SERVICE BULLETIN NO: 32-020

MODIFICATION NO: EC-06-1061, EC-07-0072

LANDING GEAR - MAIN LANDING GEAR SPECIAL BOLTS - INSPECTION AND REPLACEMENT

Special Bolts - Inspection
Figure 1

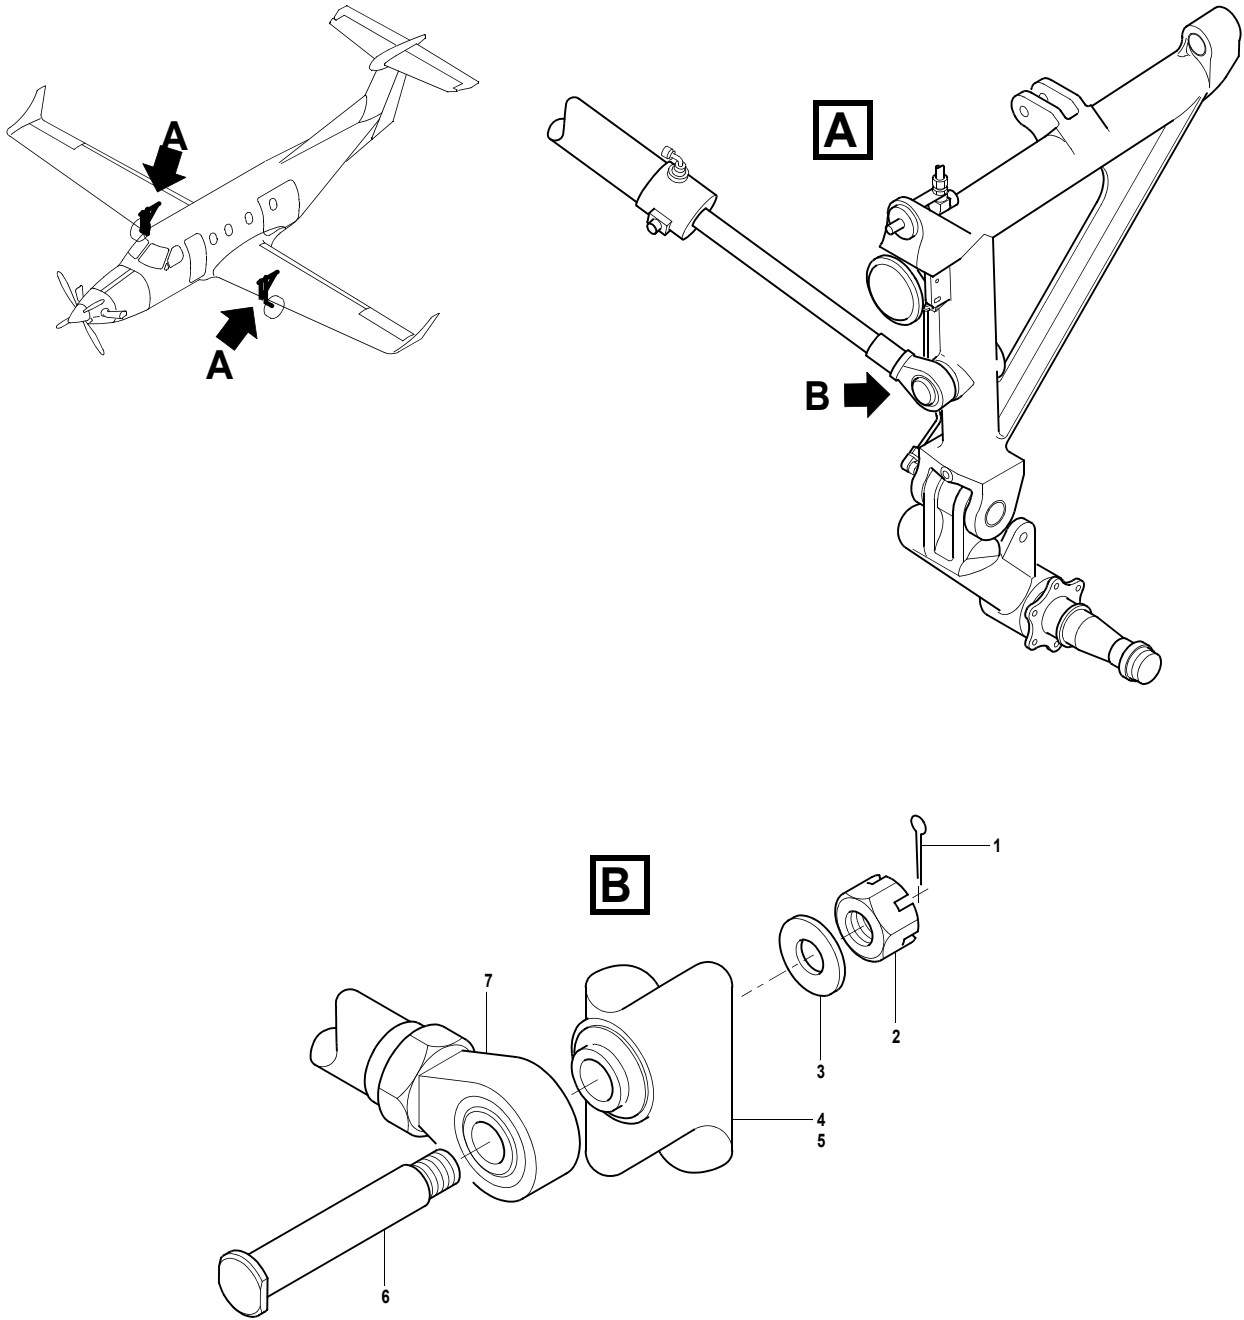
- (1) Do a check of the special bolts (2) that attach the MLG retraction actuators to the MLG assemblies for serial numbers that start with the letters AT. If you find a special bolt (2) with a serial number that starts with the letters AT, replace the bolt (Ref. 3. B.).

NOTE: On affected bolts, the serial number is permanently marked on the bolt head.

- (2) Do a check of the special bolts (1) that attach the shock absorbers to the MLG assemblies for supplier code AT. If you find a special bolt (1) with a supplier code AT, replace the special bolt (Ref. 3. B.).

NOTE: On affected bolts, the supplier code is permanently marked on the threaded (tail) end of the bolt.

Retraction Actuator - Special Bolt - Replacement
Figure 2

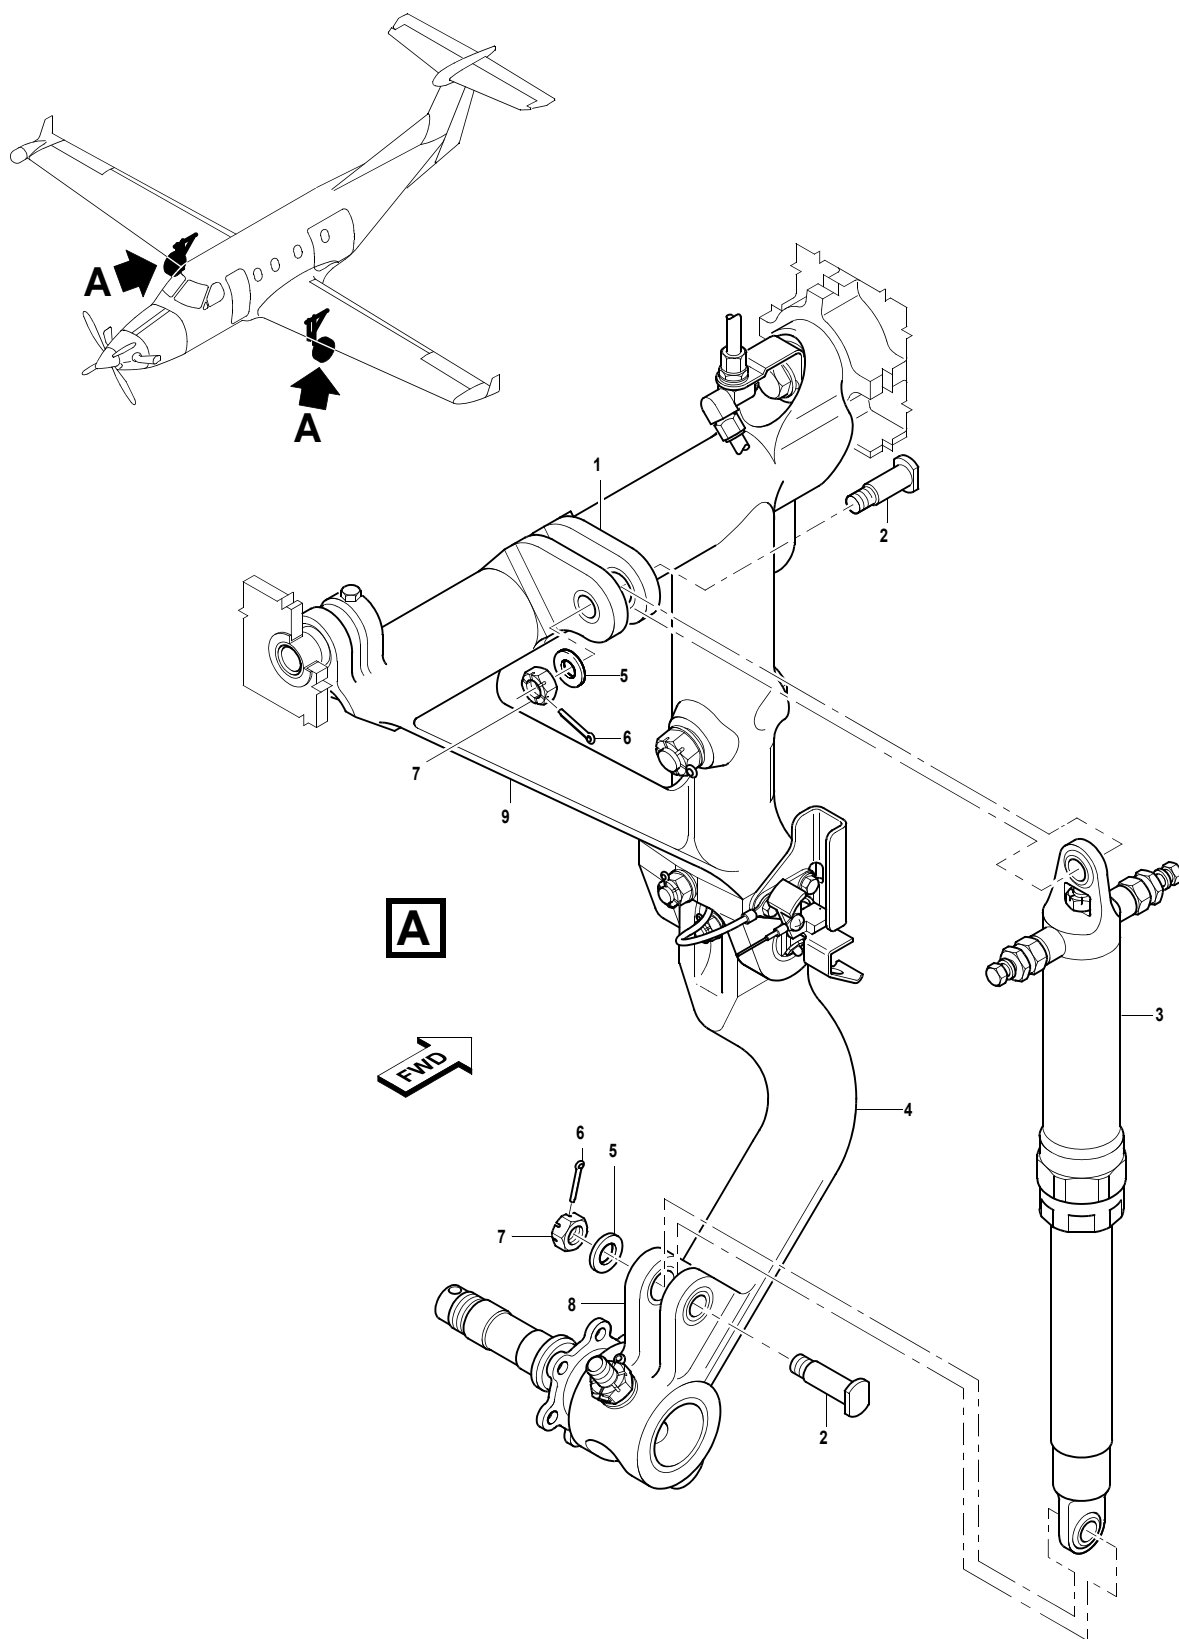
- (2) Replacement of a special bolt P/N 532.10.12.077 and P/N 532.10.12.202 (Ref. Fig. 2)

- (a) From the applicable bolt, remove the cotter pin (1), the nut (2), the washer (3) and the bolt (6) and disconnect the actuator (7) from the left MLG assembly (4). Discard the cotter pin (1), the nut (2) and the washer (3).

- (d) Apply layers of the corrosion preventative (Material No. P04-012) on the faying surfaces of the new bolt (6), the eye end of the actuator (7) and the MLG assembly (4).

- (e) Align the eye end of the actuator (7) with the bolt hole in the MLG assembly (4). Put the new bolt (6) in position.
 - (f) Put the new washer (3) on the bolt (6) and install the new nut (2).

- (g) Torque the nut (2) to between 1800 and 2000 lbf in. (200 and 220 Nm). (Ref. AMM, 20-20-01, Page Block 1).
 - (h) Use the cloth (Material No. P02-003) made moist with the solvent (Material No. P01-008) and remove the unwanted corrosion preventative (Material No. P04-012).

- (i) Install the new cotter pin (1) (Ref. AMM, 20-20-00, Page Block 1).
 - (j) Do Steps 3. B. (2)(a) thru (i) again for the right MLG assembly (5) if the special bolt fails the inspection (Ref. 3. A. (1)).
